SOL-ARK UNDERCHARGING BATTERIES

CSB Number	855-0017 REV A
Date	Oct 28, 2024

42-48-6650, 44-48-3000, 48-48-5120, 48-48-5120-H, and LYNK II

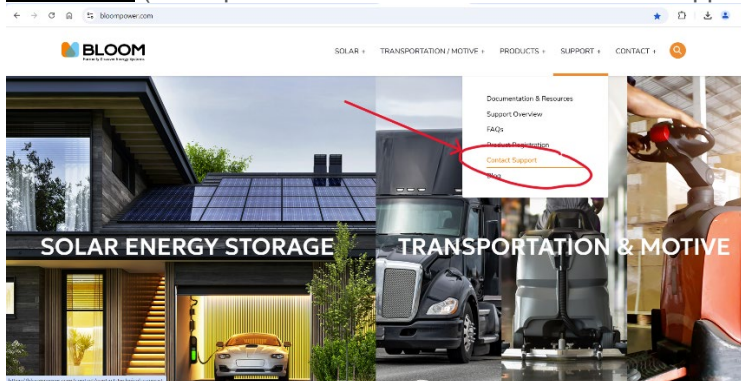
Discover/Bloom Power lithium batteries are being undercharged when they are in closed-loop communication with Sol-Ark inverters and the inverter is in grid interactive mode. Undercharging is occurring because the charge voltage being delivered to the battery is below the required voltage to charge. The condition can be observed by using LYNK ACCESS software to view the actual charge voltage delivered and comparing with the charge voltage displayed by the Sol-Ark Inverter. If a large delta between the target voltage and the actual voltage is observed corrective action is required.

The inverter is receiving the target charge voltage from the battery's BMS, but the inverter is delivering a lower voltage at the battery terminals. This large voltage drop will prevent full battery charging and is due to an unknown inverter firmware bug or control loop error.

Use LYNK ACCESS software to temporarily increase the voltage offset of the Max deltaV parameter to 2000 mV, until this issue is resolved. This will raise the charge voltage delivered to the batteries.
